Product Change Notification

113561 - 00

Change Notification #: 113561 - 00
Change Title: Intel® Server System R1208GZ4GC
PCN 113561-00, Product Design
Update the System Rear Panel, 750W Common
Redundant Power Supply, Quick Reference
Label and BIOS/ME/BMC/FRUSDR
Firmware Add a Mylar and a Plastic Block
Date of Publication: January 09, 2015

Figure One

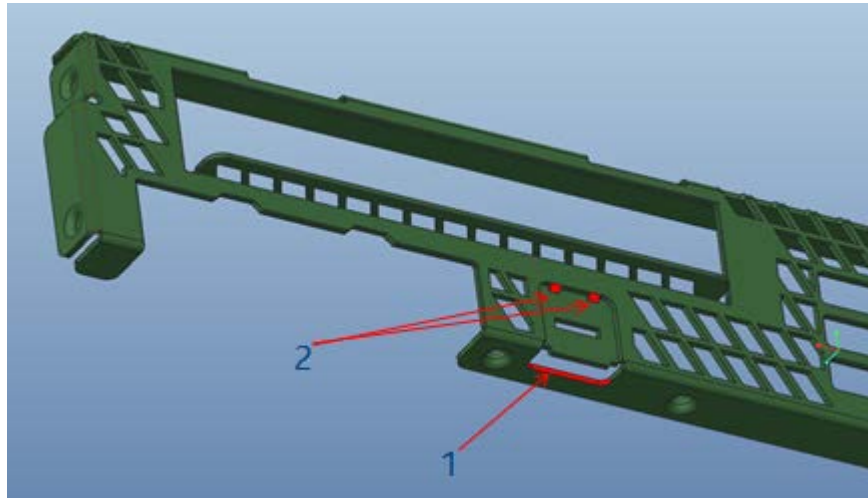
2. Add a connection at the bottom of the RMM4 (Remote Management Module 4) slot to improve structure strength. See item 1 in Figure One.
3. Update the one big center joint to two smaller joints so that the joints will not conflict with the LAN cable connector latch. See item 2 in Figure One.

Figure Two

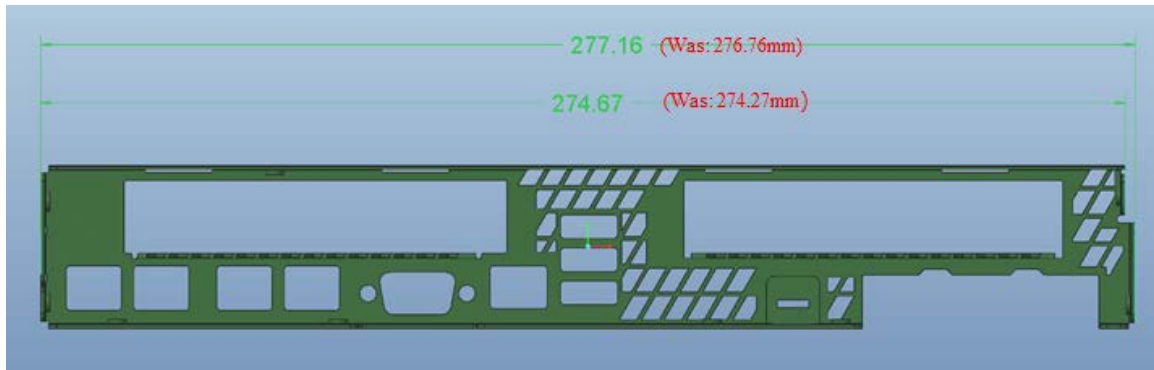
4. Enlarge by 0.2mm at both the left and right sides of the rear panel to improve the flexibility. The previous width was 276.76mm and 274.27mm. The updated width is 277.16mm and 274.67mm. See Figure Two.

Figure Three

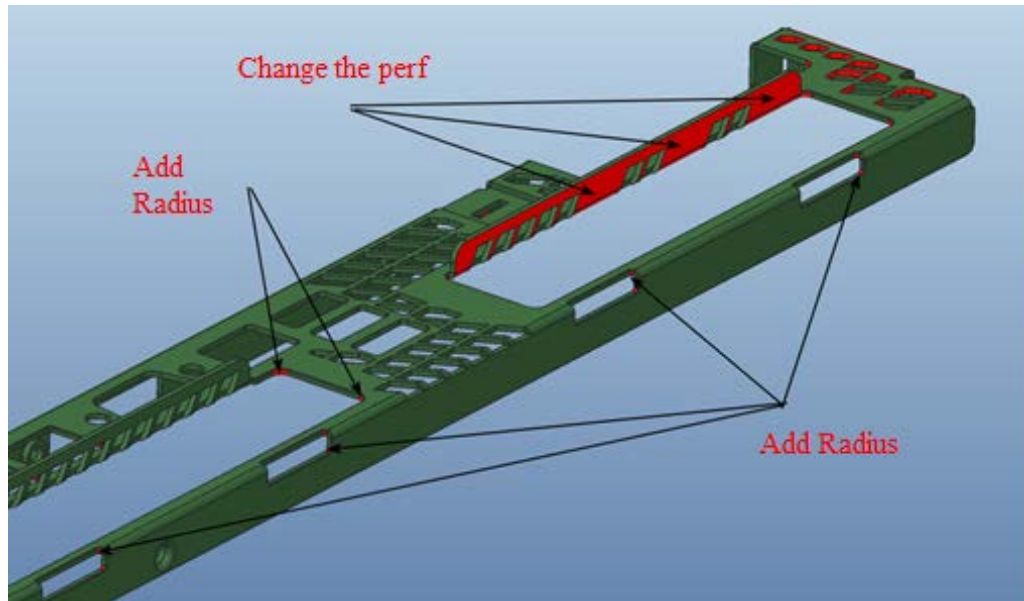
5. Update the perf and add radius to improve structure strength. See Figure Three and Figure Four.

Figure Five

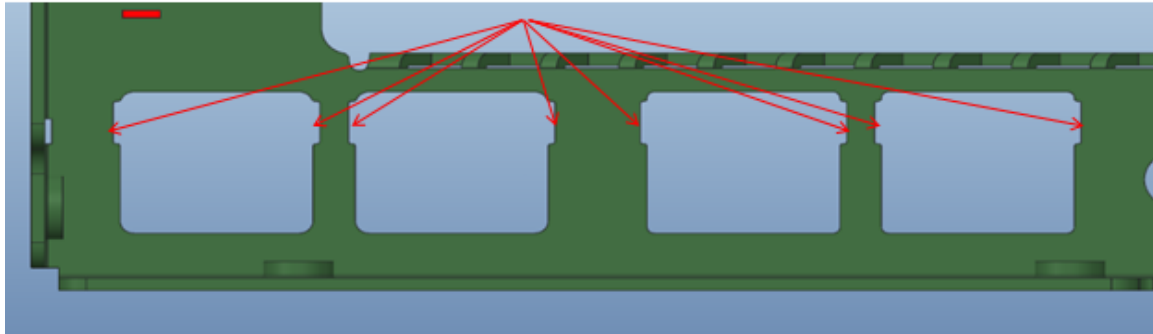
6. Add eight cut-offs around the on-board NIC (Network Interface Controller) openings to improve the LED visibility. See Figure Five.

Add eight cut-offs on rear panel on-board NIC connector opening.

Figure Six

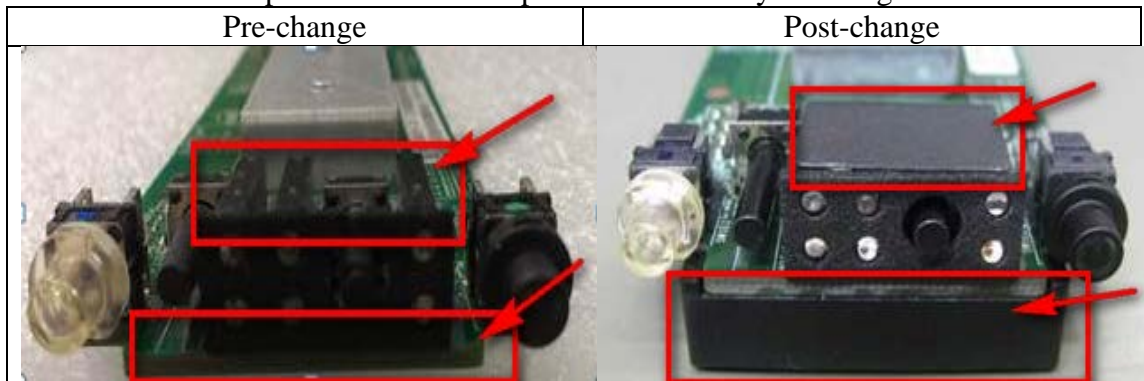
7. Add a Mylar on the top of the front panel board and add a plastic block for the front end under the front panel board to hold parts more securely. See Figure Six.

Figure Seven

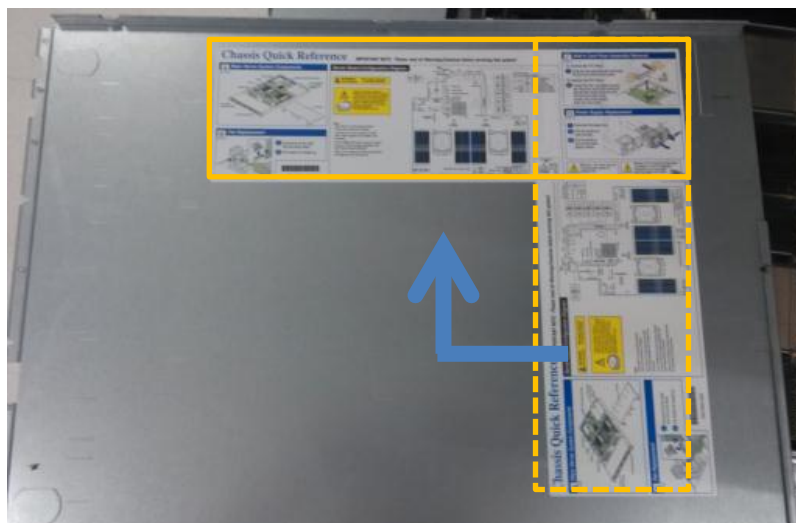
8. Rotate the orientation of the Quick Reference Label by 90 degree. The new location of the label is above the power supply unit cage and the air duct. See Figure Seven.
